Job Name: Land at Grange Farm, Cannington

Job N^o: IMA-18-040

Client: A&M Hollis

Technical Note 1: Issues Raised in Local Highway Authority Consultation Response

Figures TN1-1 to 5

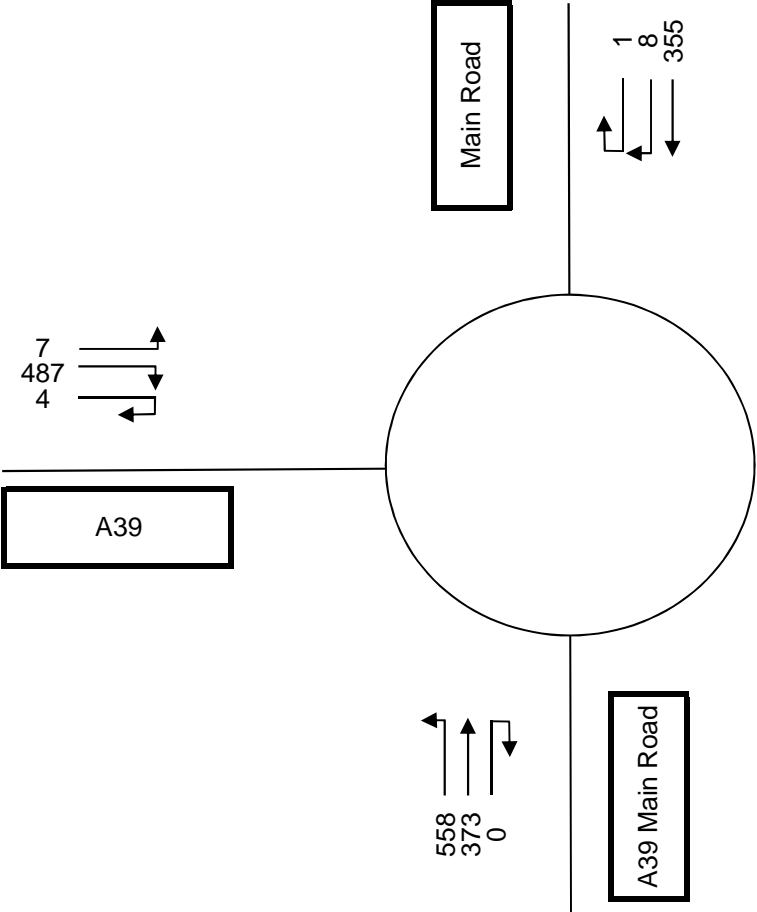
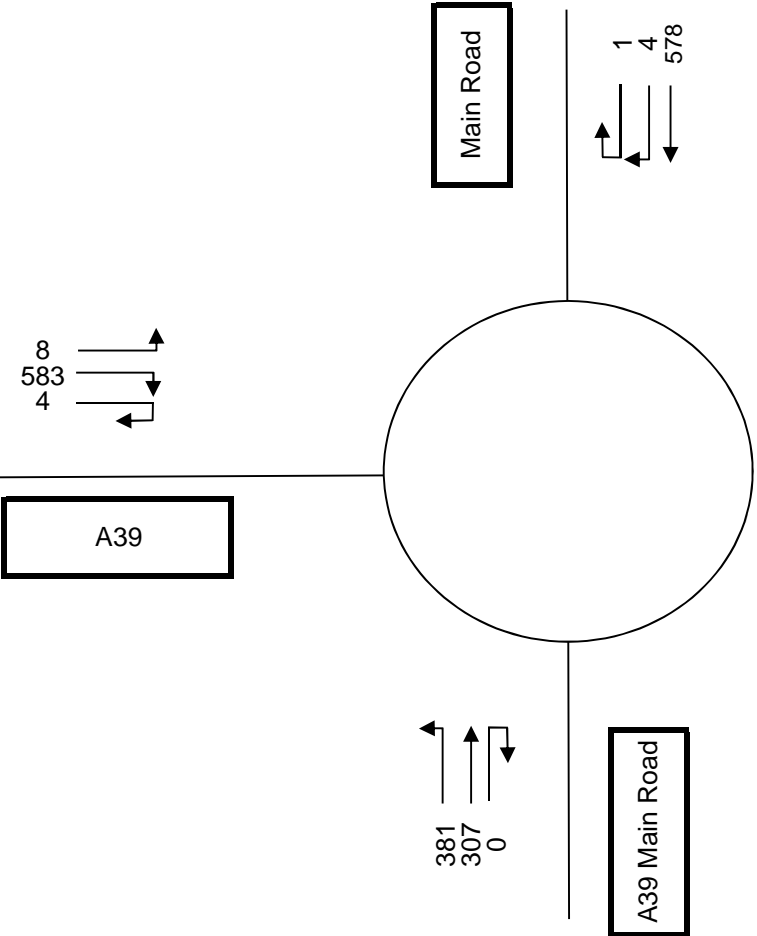
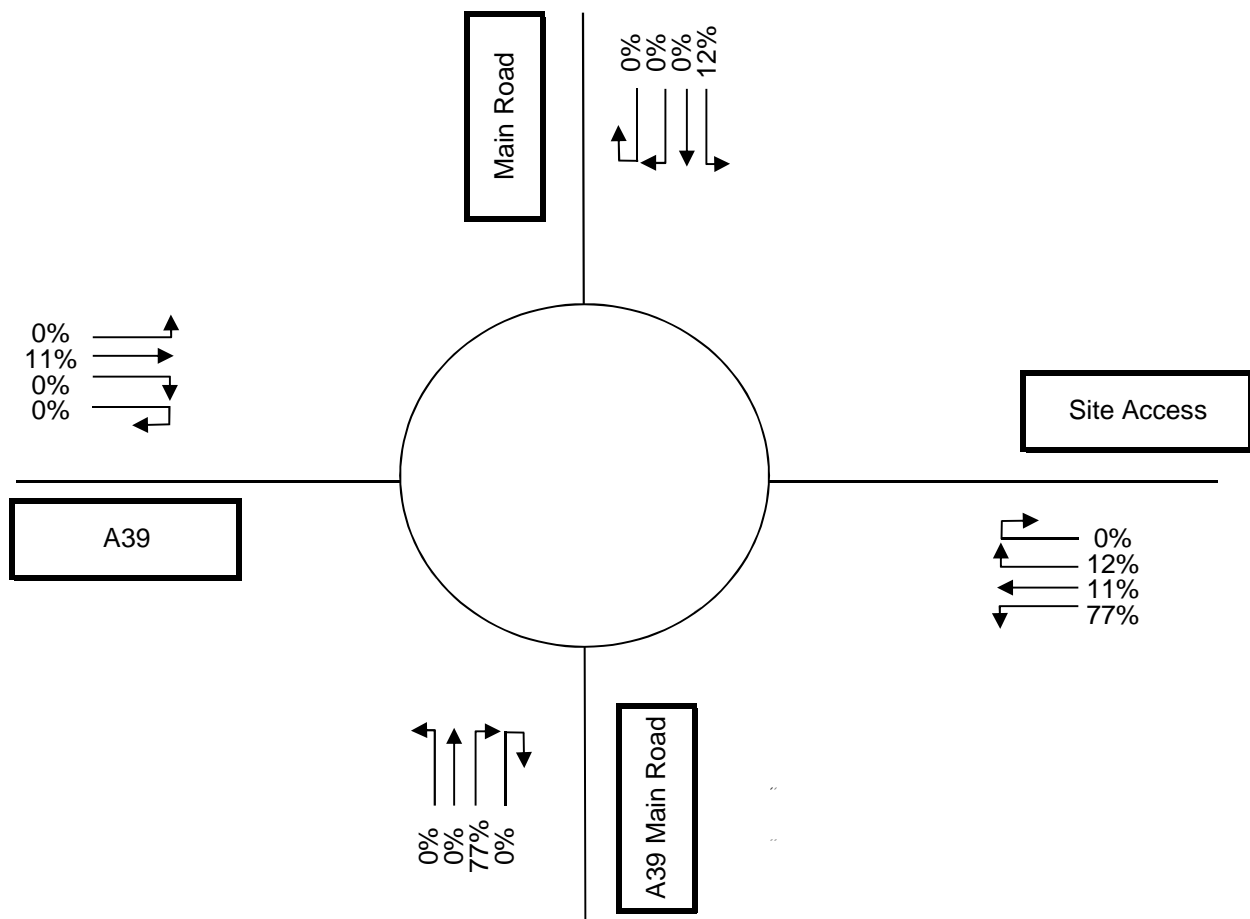
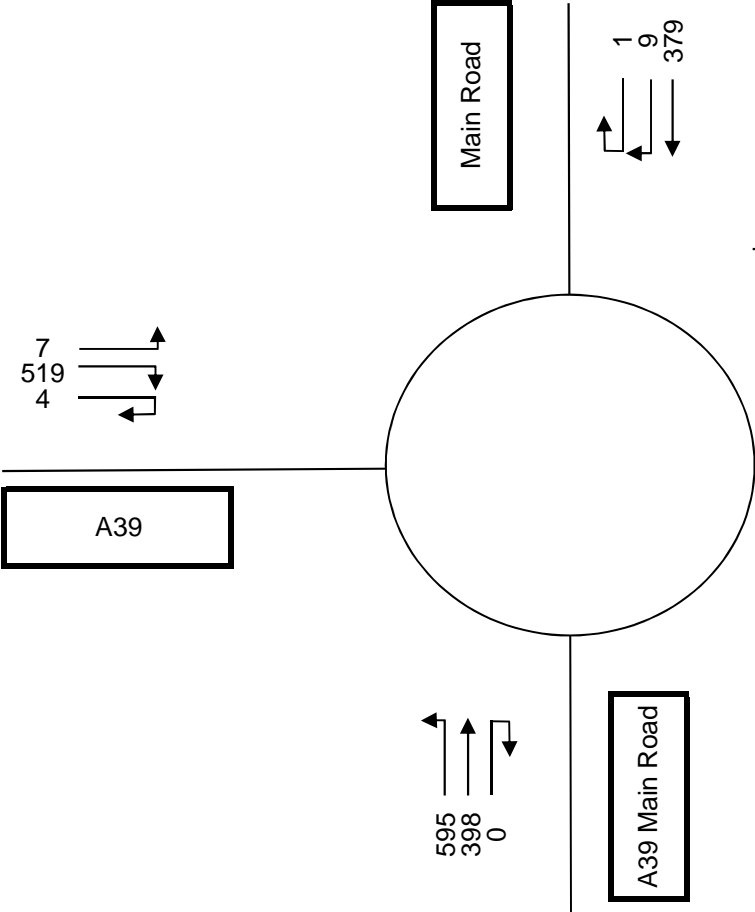
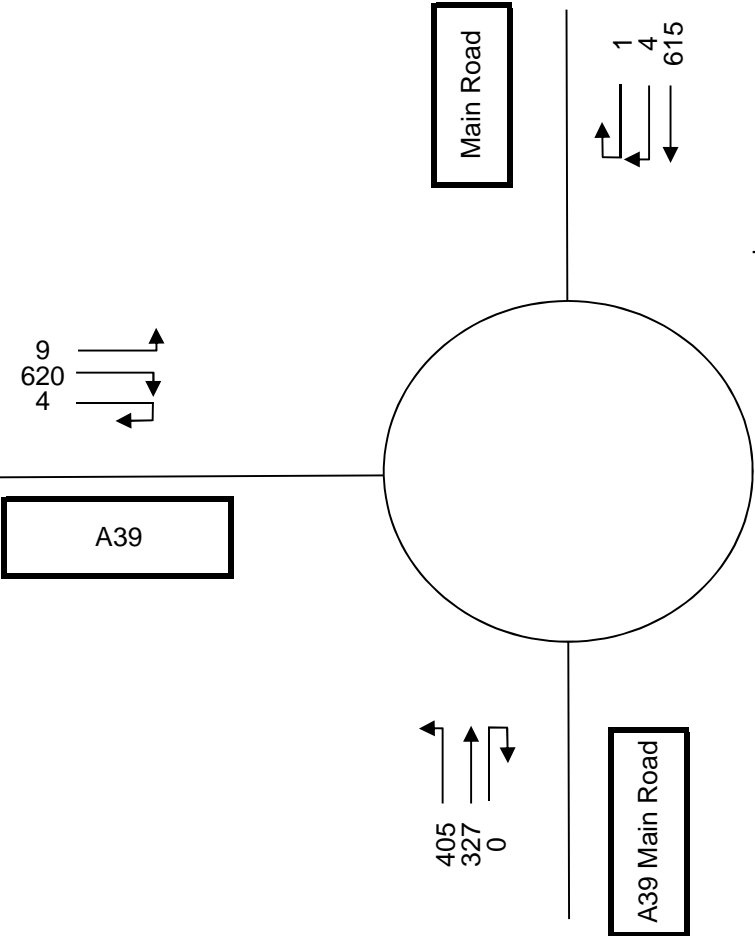
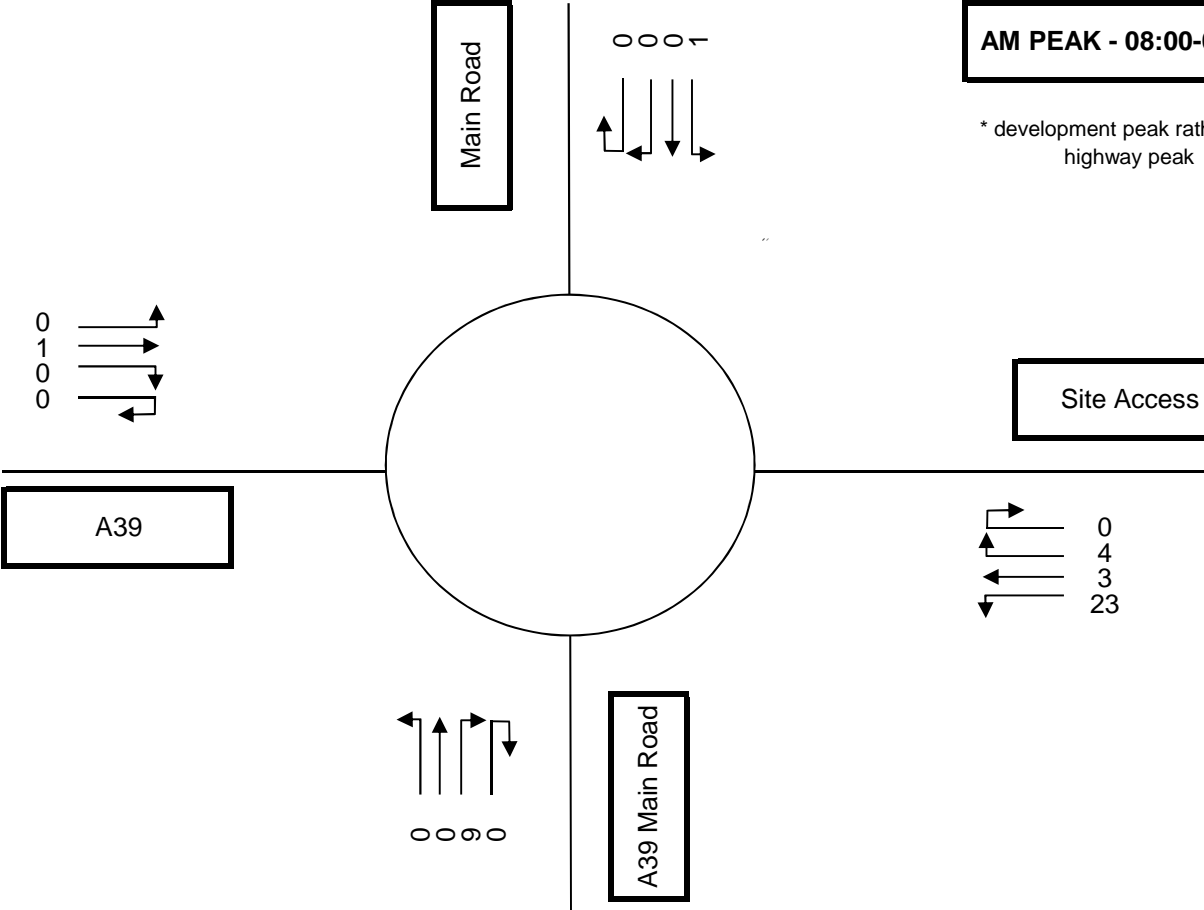
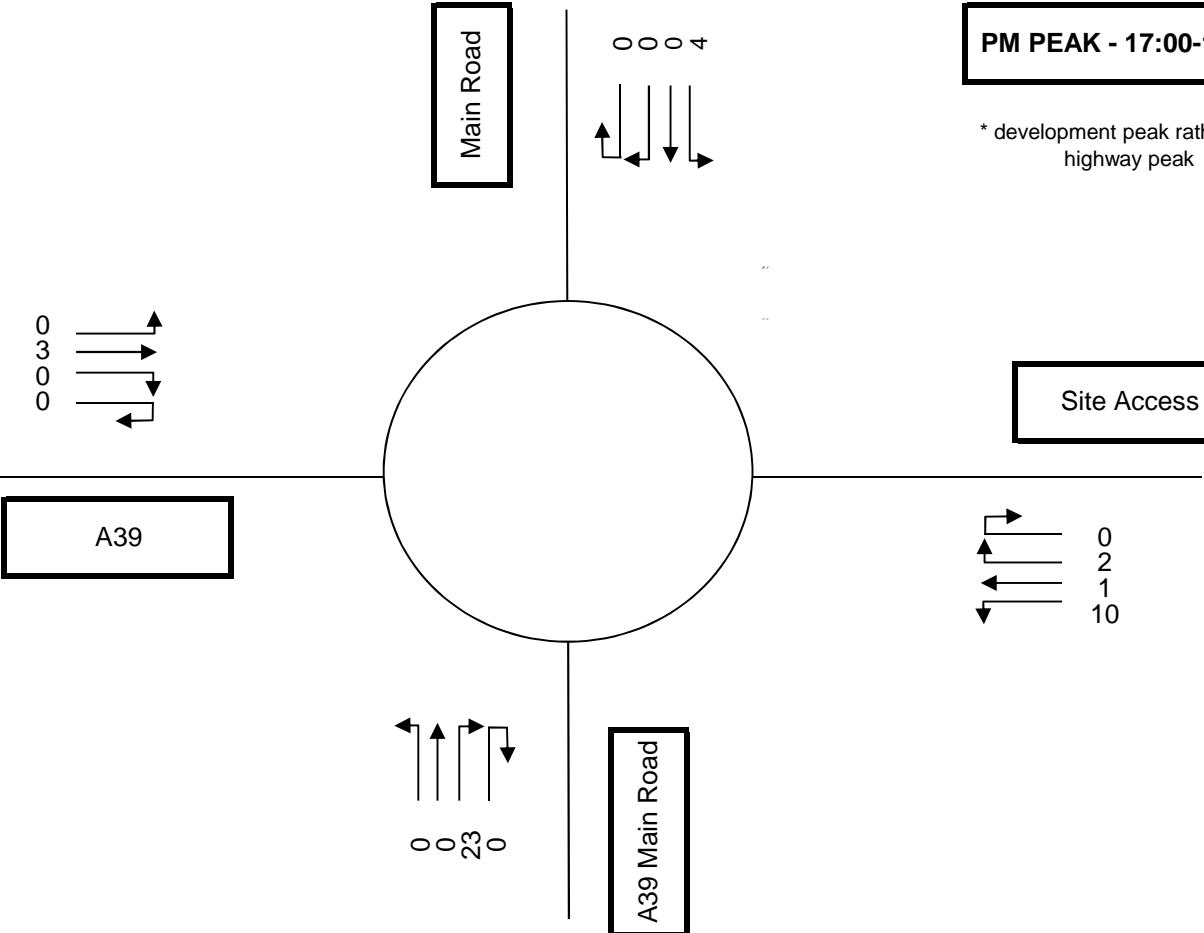
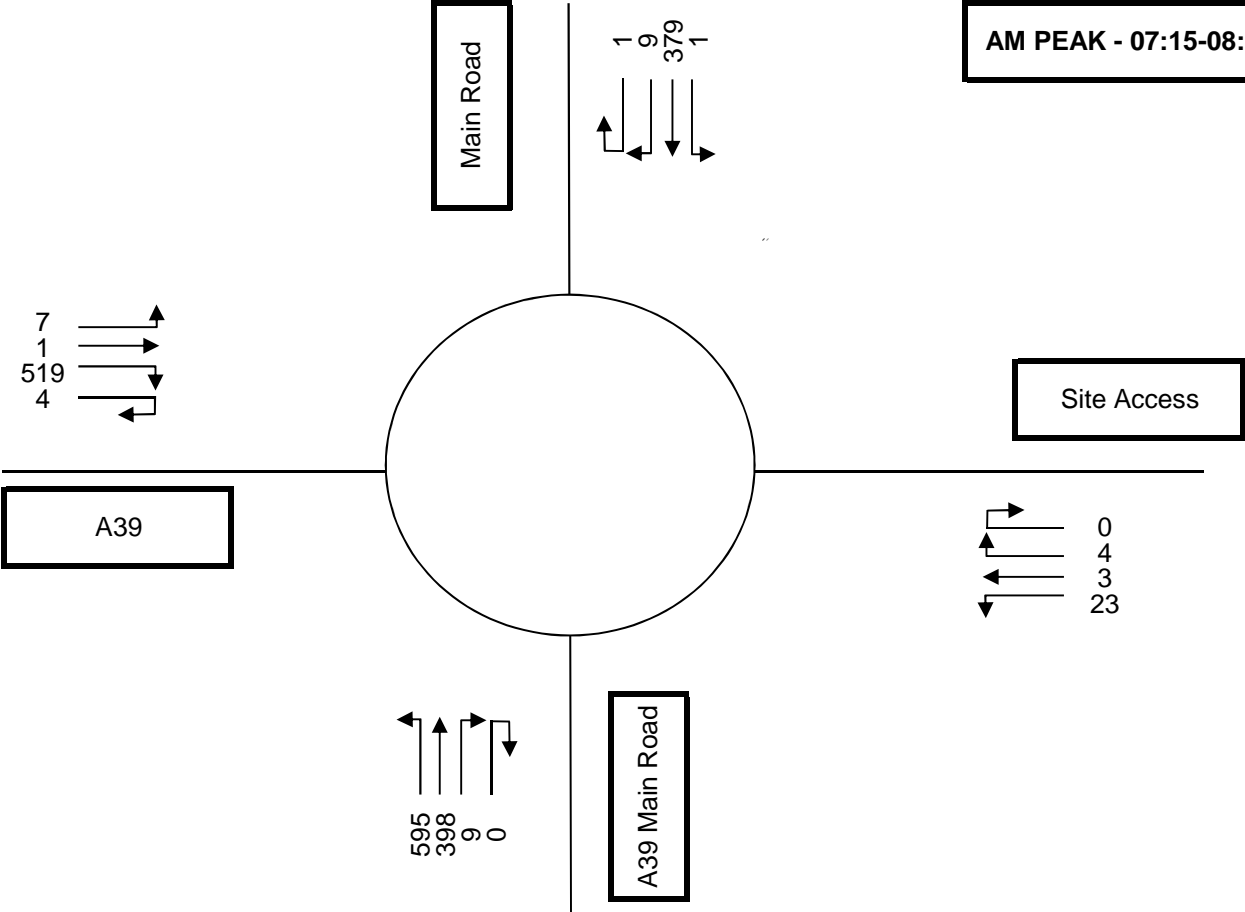
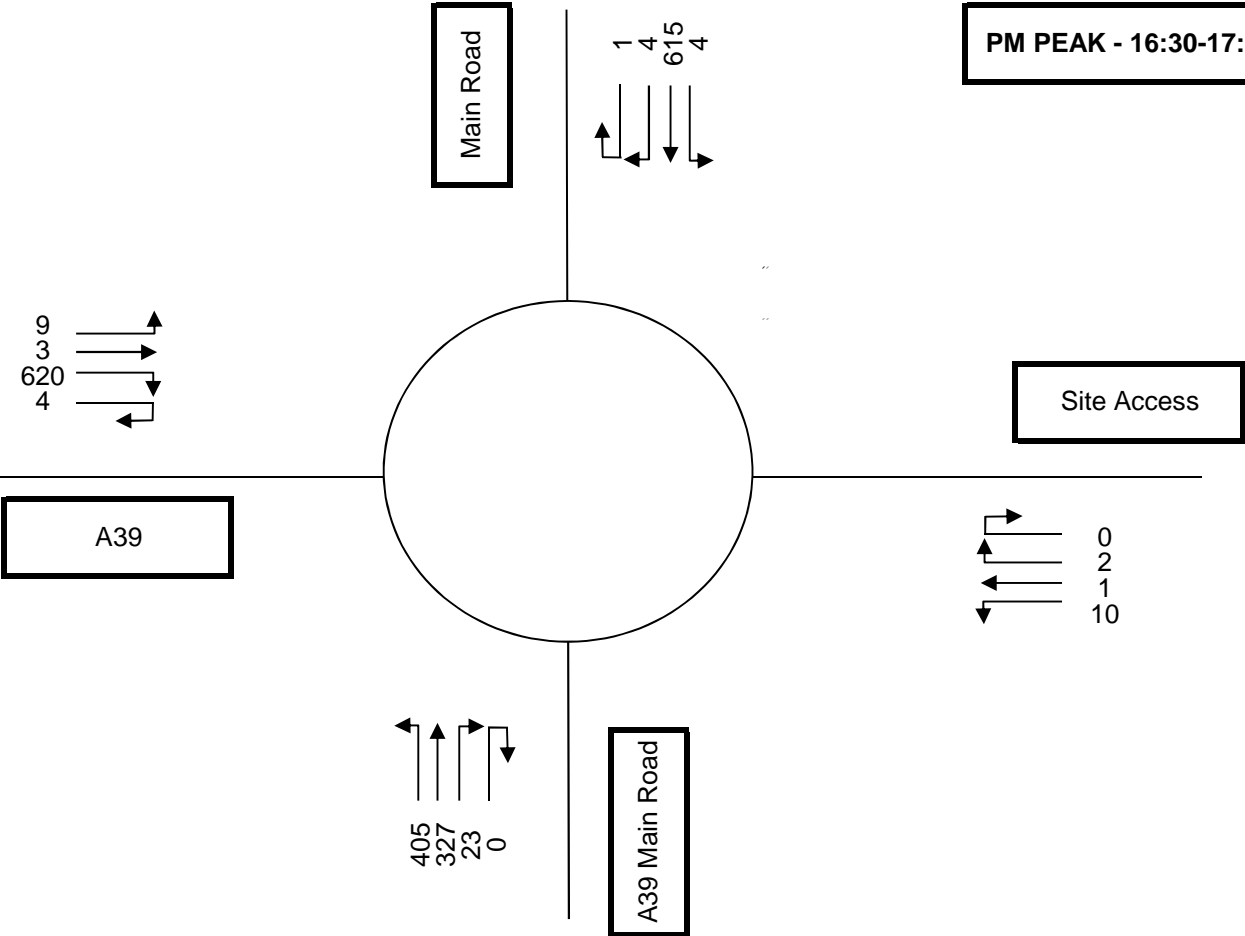
- 2.1 The LHA commented that the TA assumed standard peak hours (08:00-09:00 and 17:00-18:00) rather than considering the peak hours from the traffic surveys, which WSP stated fell in the periods 07:30-08:30 and 16:30-17:30, when flows were higher.

- 2.4 The survey data has been re-analysed and the weekday AM peak at the roundabout actually falls in the period 07:15 to 08:15. Revised traffic flows for the peak hours of 07:15-08:15 and 16:30-17:30 are shown in Figures TN1-1 to 5.

- 2.5 As a worst-case, the development traffic flows are still based on the development peak rather than the revised highway peak.

(Plans IMA-18-040-007 to 009)

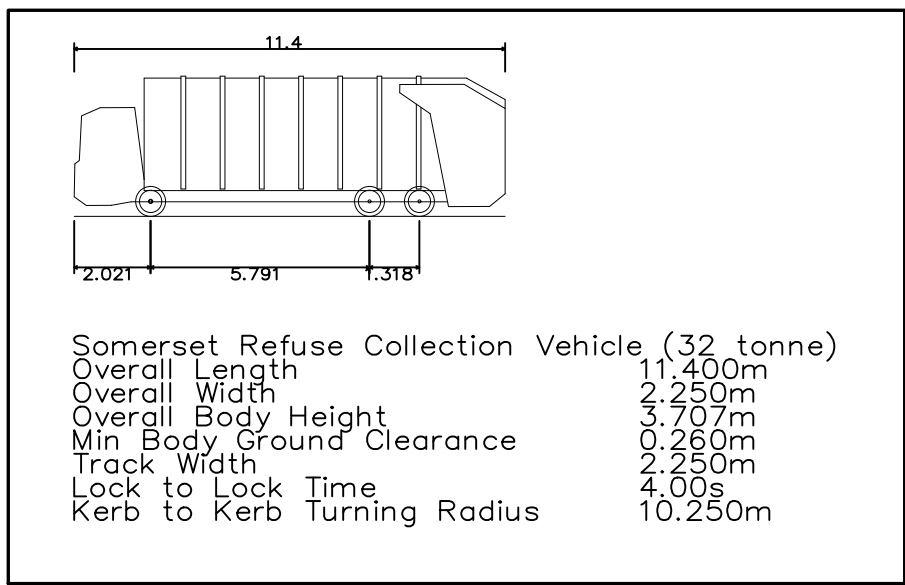
- Timing of the peak hours
- Visibility at new roundabout entry
- Geometry of new roundabout entry
- Road Safety Audit issues

- 3.1 Plots of forward visibility onto the circulating carriageway and visibility to the right on entry have been added to plan IMA-18-040-008, included in Appendix TN1-2. There are no issues with visibility at the proposed access.

- 4.1 Entry and exit widths at the proposed site access have been widened to 4.5m at the request of the LHA, with entry deflection maintained. The revised general arrangement plan (IMA-18-040-007) is included in Appendix TN1-2.

- 4.4 The swept path of a Refuse Collection Vehicle to Somerset Waste Partnership standards is shown in Plan IMA-18-040-009, included in Appendix TN1-2.

- 5 Road Safety Audit Issues
- 5.1 An issue regarding alignment of the proposed access onto the roundabout has been noted and addressed in the new general arrangement plan (IMA-18-040-007 in Appendix TN1-2) when considering the access widening and swept path analysis requested by the LHA.

- 5.3 The entry to the off-road shared-use footway/cycleway that exists along the east side of the A39 has been modified to enable cyclists to join it away from the mouth of the roundabout entry (see plan IMA-18-040-007 in Appendix TN1-2).
